Serial: NPD-NRC-2011-081
December 7, 2011

**LEVY NUCLEAR PLANT, UNITS 1 AND 2
DOCKET NOS. 52-029 AND 52-030
VOLUNTARY SUBMITTAL RELATED TO THE LIQUID WASTE MANAGEMENT SYSTEM
DESCRIBED IN CHAPTER 11 OF THE FINAL SAFETY ANALYSIS REPORT - SUPPLEMENT 1**

PGN RAI ID #: L-0995

Progress Energy Florida
 Levy Nuclear Plant
 Units 1 and 2
 Part 2, Final Safety Analysis Report
 Circulating Water System and Raw
 Water System (Saltwater Subsystem)
 FIGURE 10.4-201 Rev 4

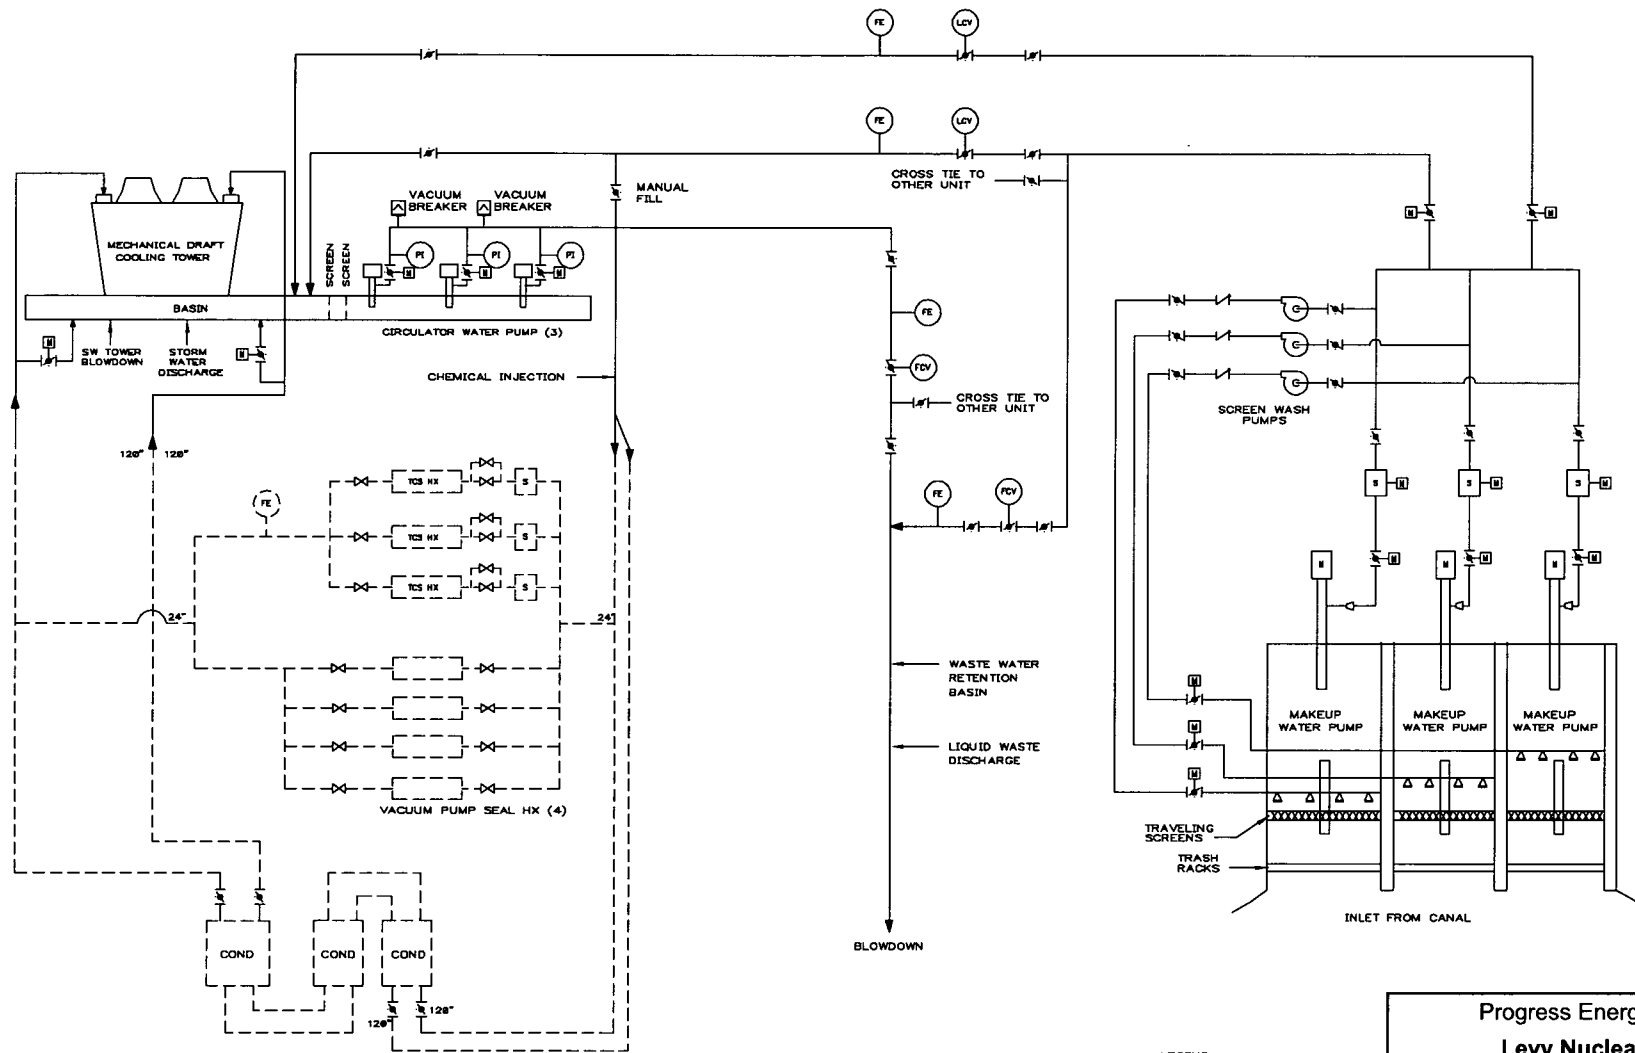
An additional revision to FSAR Subsection 11.2.1.2.4, Controlled Release of Radioactivity, and a revision to Figure 10.4-201 is described below to incorporate information on the blowdown line vacuum breakers.

- 2) Revise FSAR Figure 10.4-201 as shown in the attachment.

The exterior radwaste discharge piping is enclosed within a guard pipe and monitored for leakage. The radwaste discharge piping connects to the cooling tower blowdown piping. The double wall radwaste discharge piping terminates at this connection. Dilution of the radwaste with cooling tower blowdown occurs at this connection. Upstream of the connection point, at the high point on the system, two vacuum breakers

exist on the blowdown line to preclude water hammer during pump shutdown and startup and ensure the continued integrity of the line. The vacuum breaker location is shown on Figure 10.4-201; this location ensures liquid radwaste always remains downstream of the vacuum breakers. Planned liquid radwaste releases are only executed with dilution flow established either from the blowdown or Salt Water Sub-System of the Raw Water System.
